ULNRC- 04558

**DOCKET NUMBER 50-483
CALLAWAY PLANT
UNION ELECTRIC COMPANY
RESPONSE TO REQUEST FOR ADDITIONAL INFORMATION
ON REVISION TO TECHNICAL SPECIFICATION 5.5.9
"STEAM GENERATOR (SG) TUBE SURVEILLANCE PROGRAM"**

**REQUEST FOR ADDITIONAL INFORMATION
REVIEW OF THE CALLAWAY PLANT APPLICATION
FOR REVISION TO TECHNICAL SPECIFICATION 3/4.4
TAC NUMBER: MB1214**

Figure R6-1. Calibration Standard 1246536C-1: Parent Tube Region Flaws
Axial Shear Wave Detection

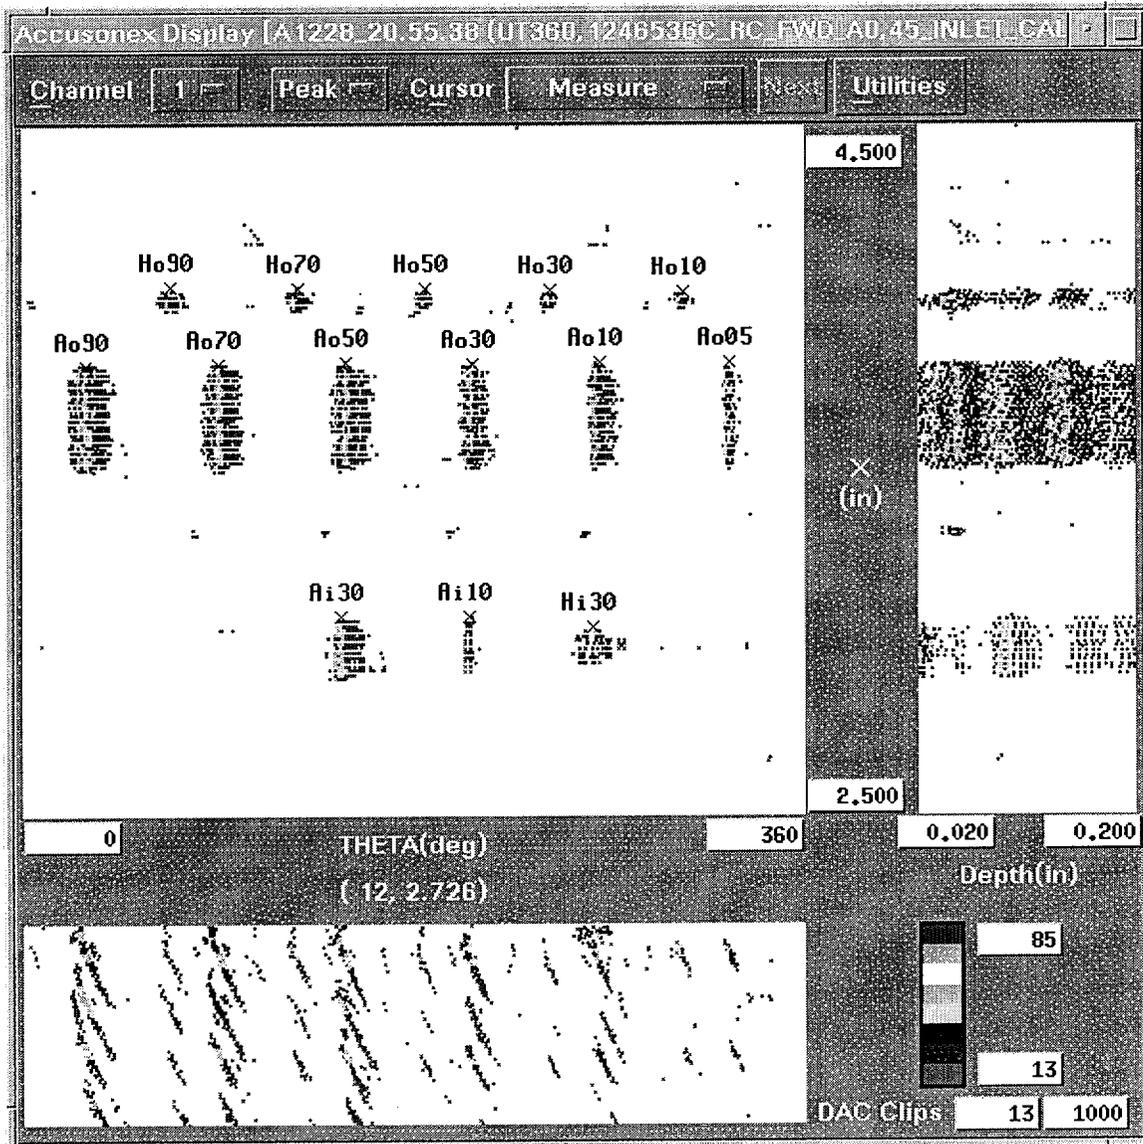
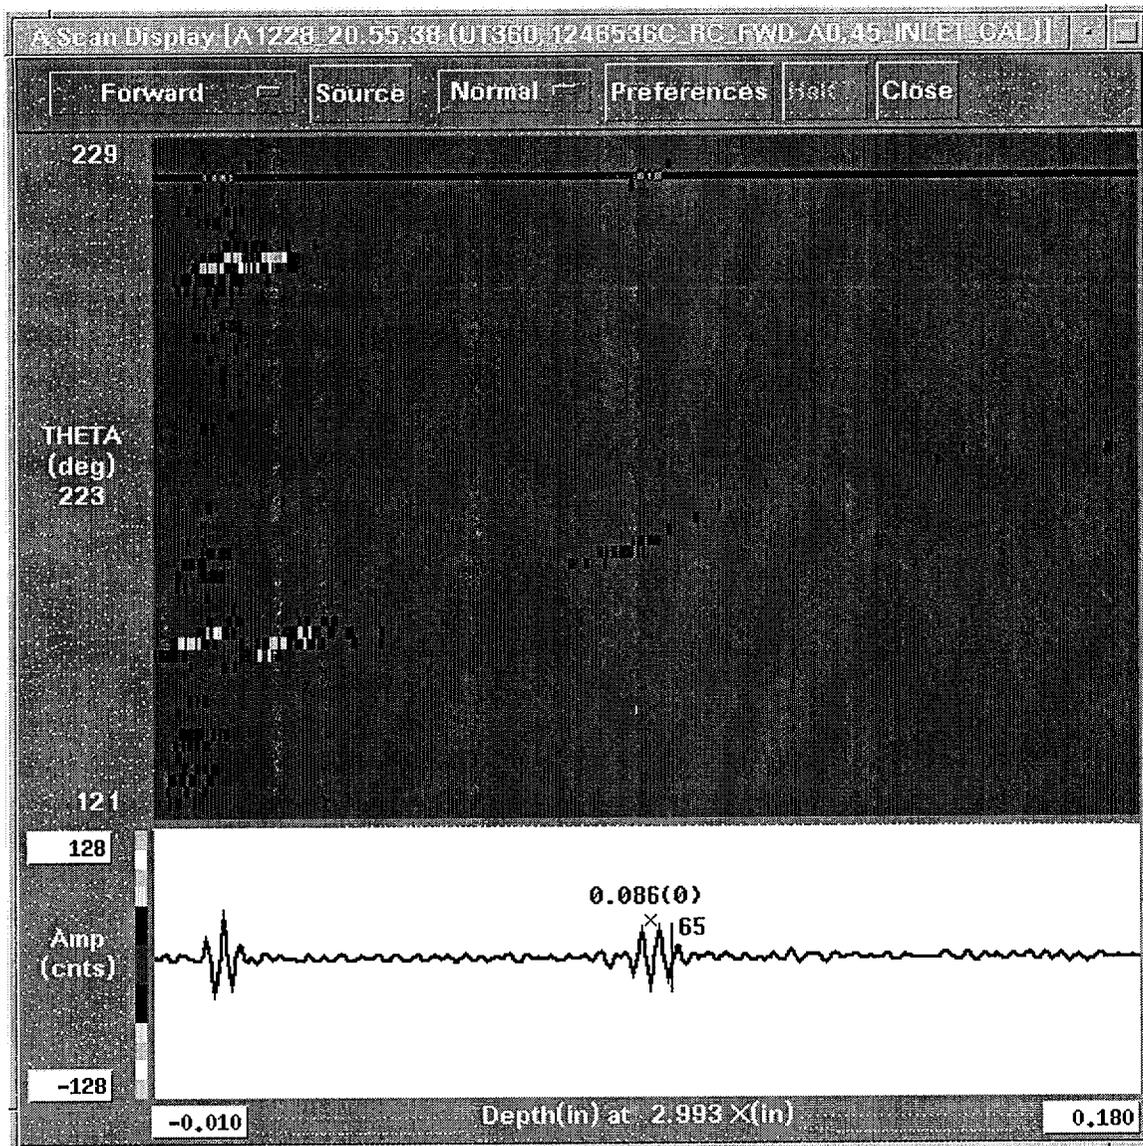
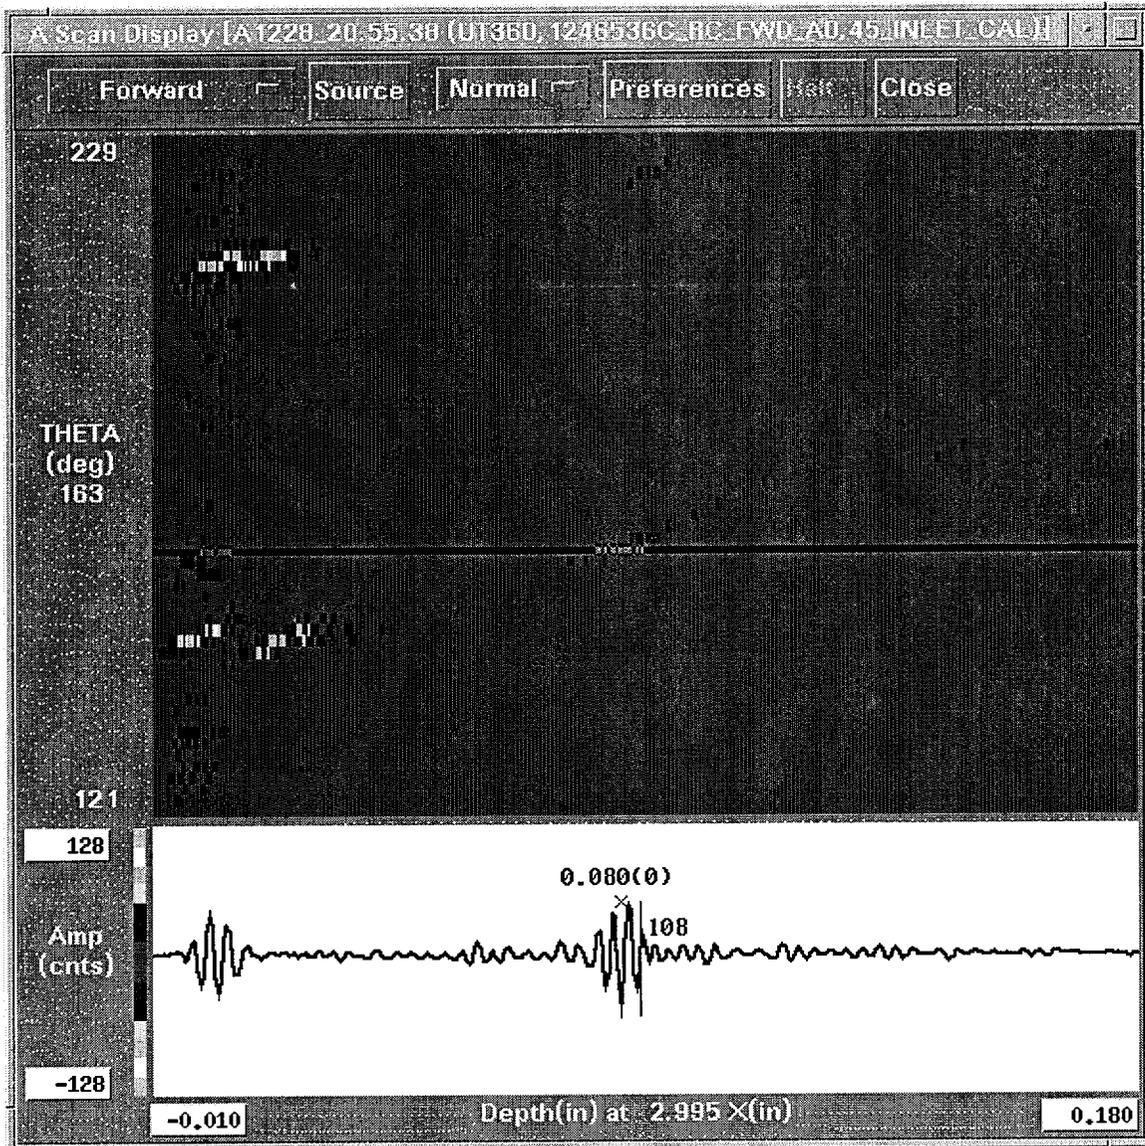
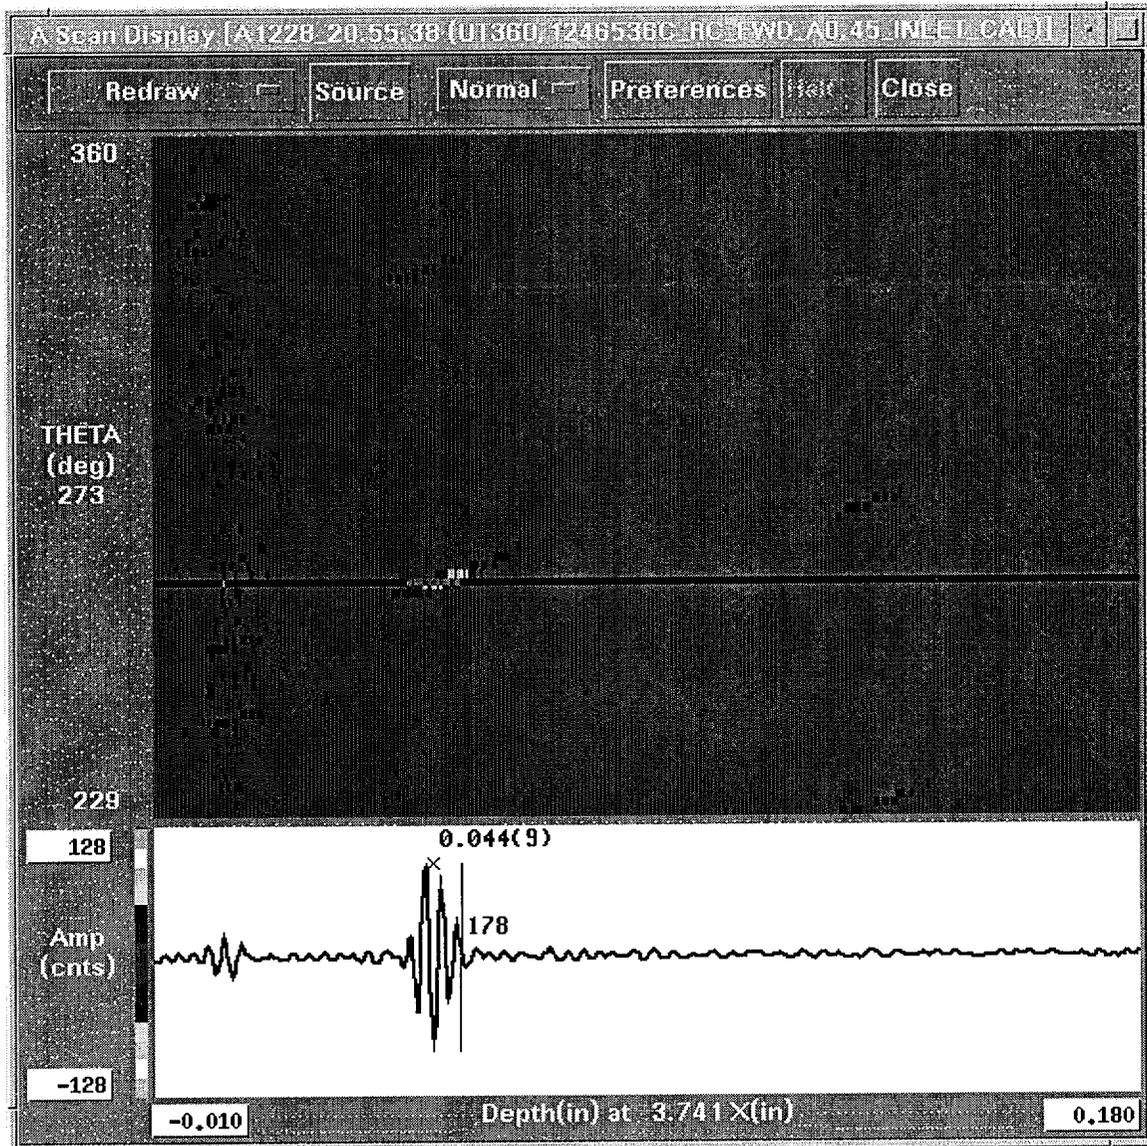
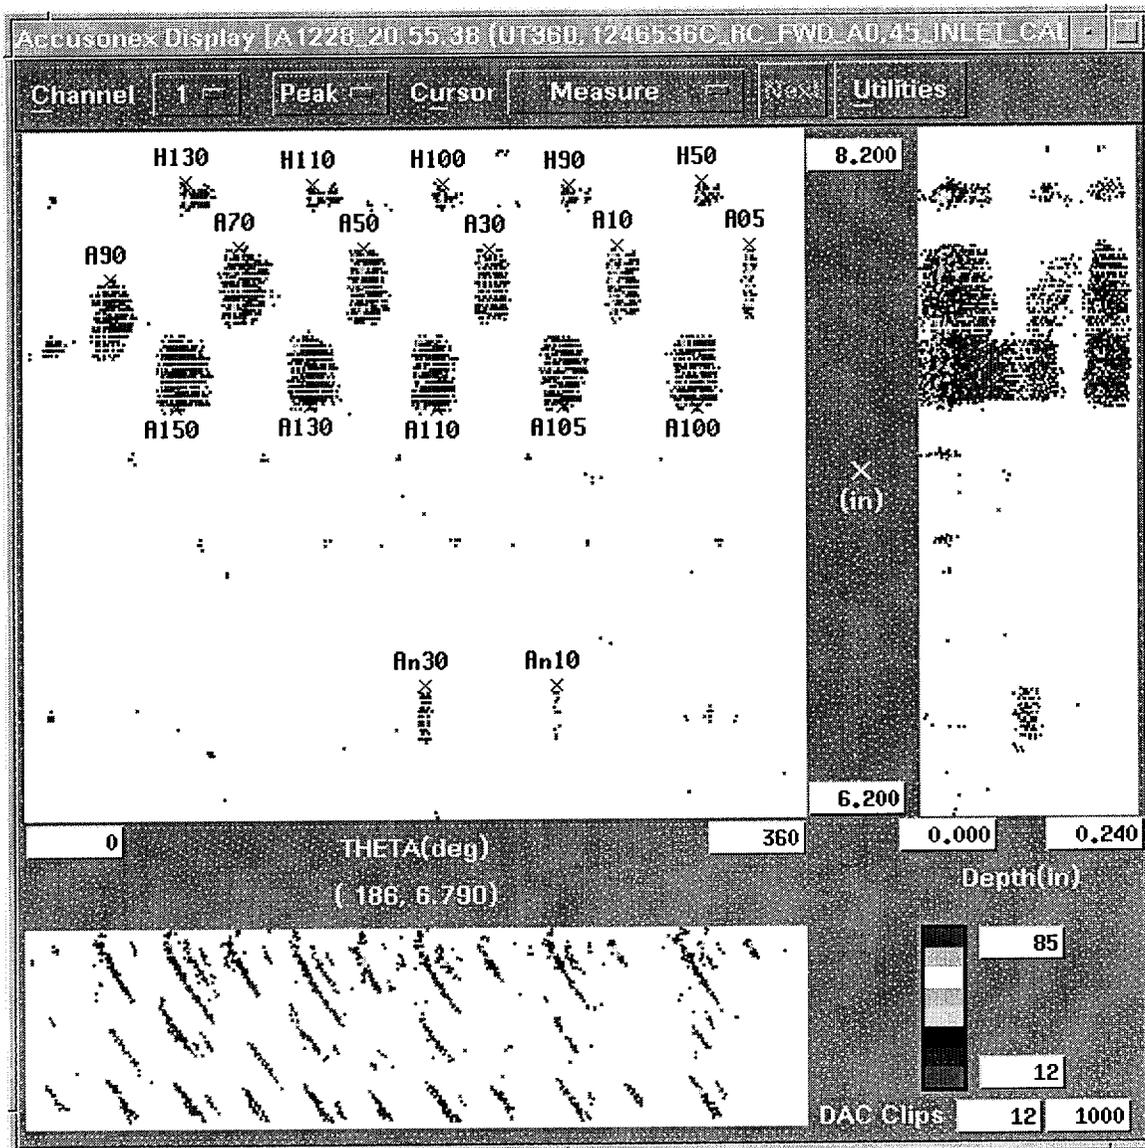
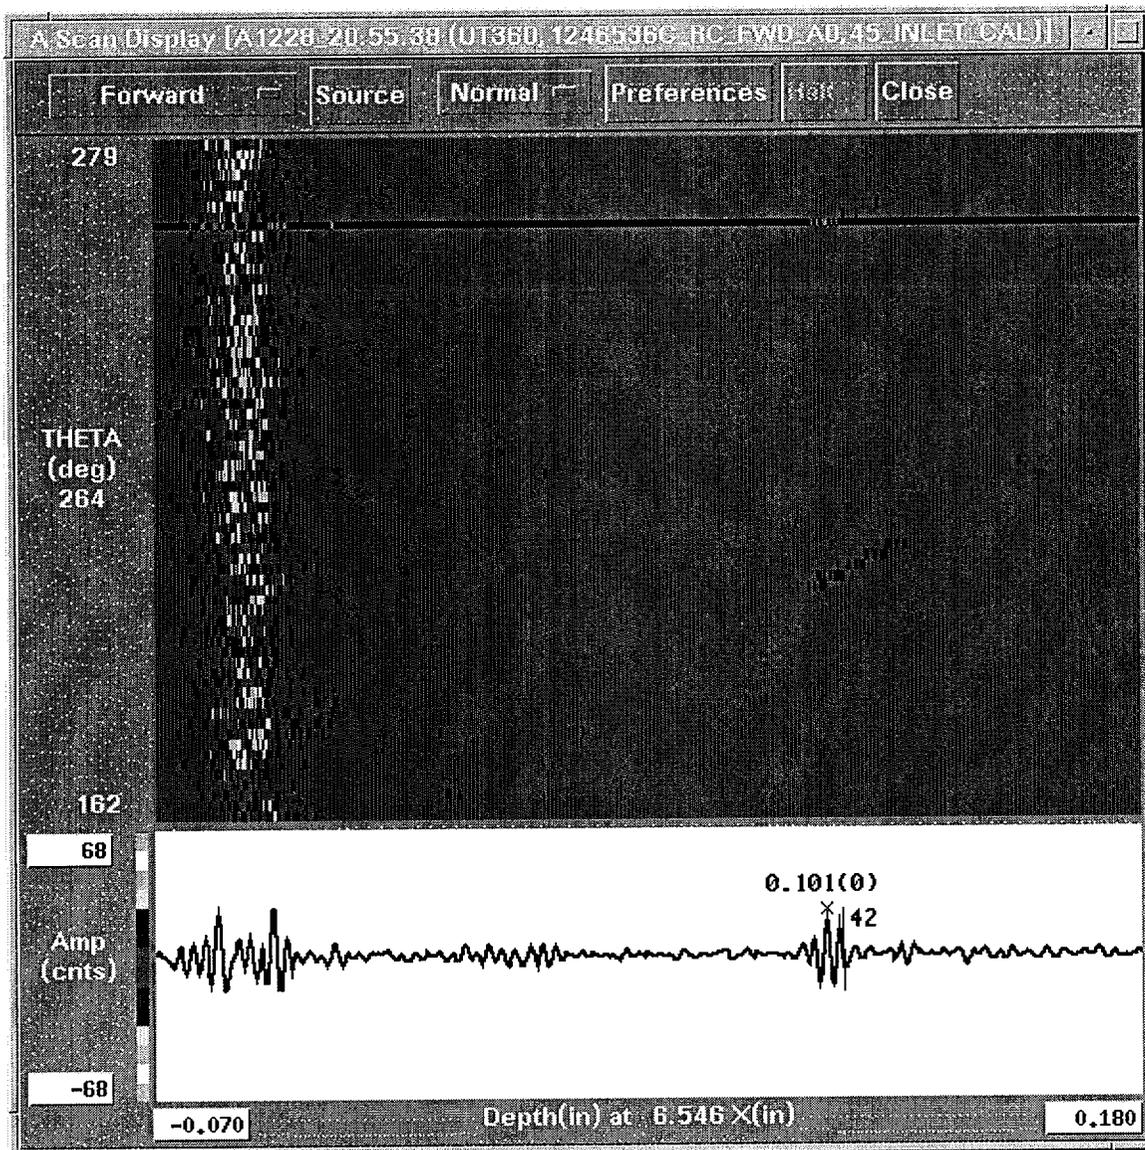
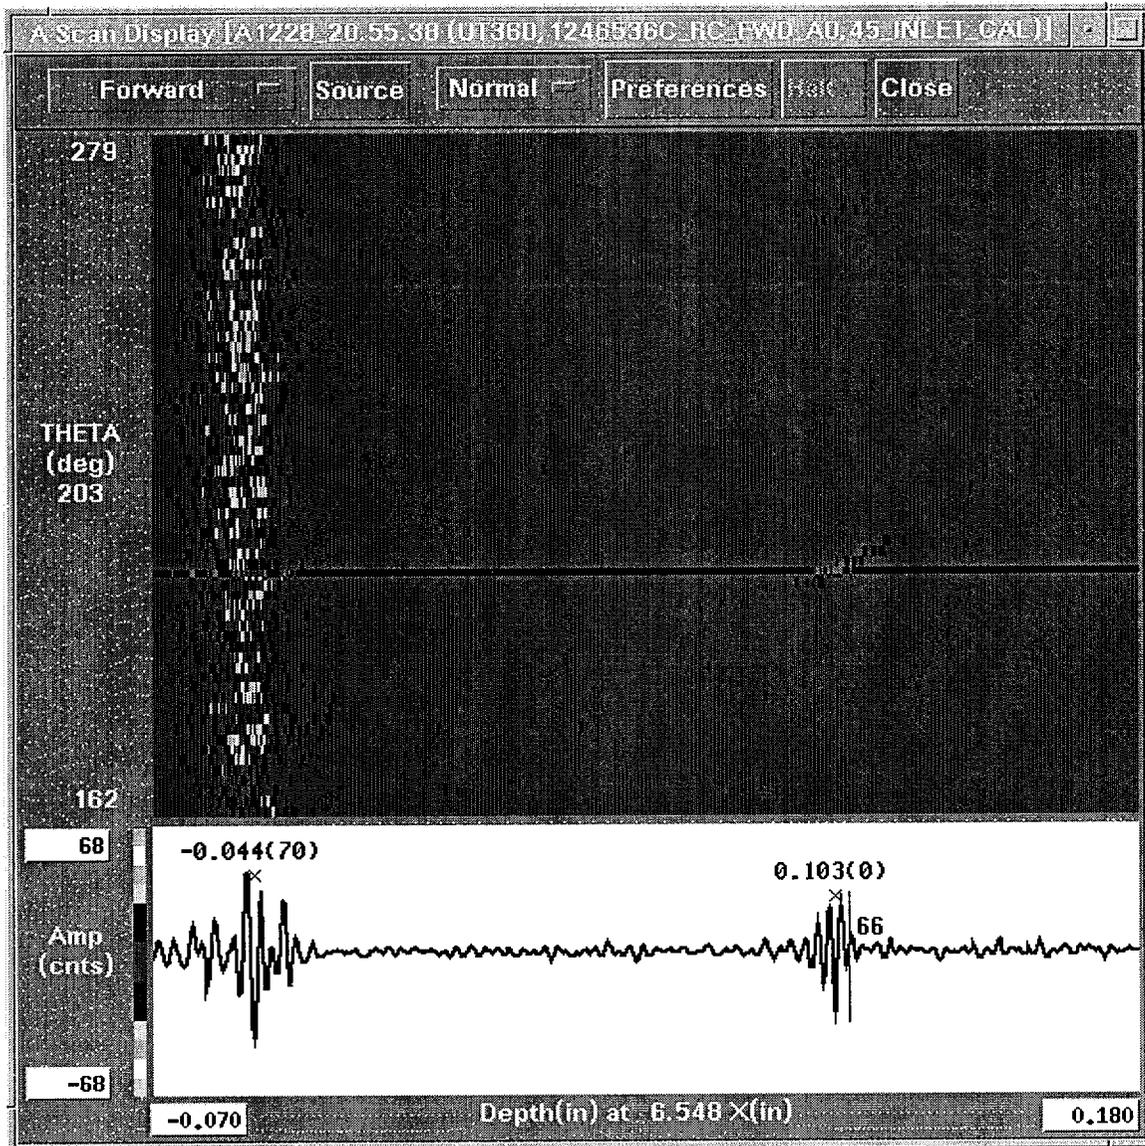
RAI # 6. During the meeting, FTI indicated that PWSCC detectability in the sleeve could be inferred from the ID notches in the UT calibration standards and the data sets containing pits. It is not clear to the staff how detecting EDM notches in the calibration standards or another degradation morphology such as pits would infer an ability to detect tight flaws such as PWSCC. Explain the basis for the statement that sleeve PWSCC ID defects will be detected, and the resulting sensitivity and POD, since the peer review (ETSS # 98404) only covers volumetric defects. Please provide additional discussion or, preferably, additional data to support the claims of the capability of the technique to detect PWSCC in the sleeve. (Question from the 6/7/01 meeting held with UE, FTI, and the NRC staff)

The assertion about the calibration standard and the inner diameter sleeve pit was to demonstrate sensitivity of the ultrasonic technique to inner diameter initiated flaws. The inner diameter pit provides a difficult cross-sectional target due to its cylindrical shape. This was felt to be a more challenging test of the detection capability of the shear wave transducers than the broad side of an EDM notch. The staff is correct in their opinion that neither of these flaws fully represent PWSCC, but these are the only morphologies available for evaluation since sleeve SCC cannot be fabricated.

To support the assertion that the system, (probe and technique) are sensitive to inner diameter flaws, three separate presentations will be offered. The first will show the sensitivity of the system to the inner diameter EDM notches in a calibration standard. The data was acquired in accordance with the

The flaws labeled "Ai" are parent tube inner diameter axial EDM notches. The flaws labeled "Ao" are parent tube outer diameter axial EDM notches. The flaws labeled with the first character "H" are EDM contoured bottom holes. Of interest is the detection of "Ai10", the 0.004 inch deep inner diameter notch.

This is the A-Scan plot showing the inner diameter corner reflection, (full skip) for the notch "Ai10". The notch is at the expected depth for the full skip, (two times the wall thickness) 0.086 inch. The peak to peak amplitude of this reflection is 65 counts out of a possible 256 counts or 25% full screen height.

This is the A-Scan plot showing the inner diameter corner reflection, (full skip) for the notch "Ai30". The peak to peak amplitude of this reflection is 108 counts or 42% full screen height.

This is the axial EDM notch that is used to establish the sensitivity and time-of-flight to depth calibration. The sensitivity must be set between 50% and 80% of the digitizer full scale. For an eight bit digitizer, the full scale is 256 counts (cnts). The amplitude of this reflection is 178 counts or (178/256), 70%.
